# PROJECT INSPECTION

<b>Company</b>	Helio	<b>Type of Inspection:</b>	SCC USE ONLY: General Contractor Review
<b>Project</b>	Venue	<b>Date of Inspection</b>	November 15, 2021
<b>Inspector Name</b>	Jeremy Chavez	<b>Time of Inspection</b>	11:40 AM

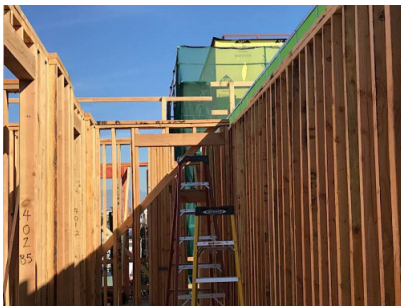
Employee is wearing sunglasses that are not ANSI rated.

Please ensure ANSI rated safety glasses are worn.
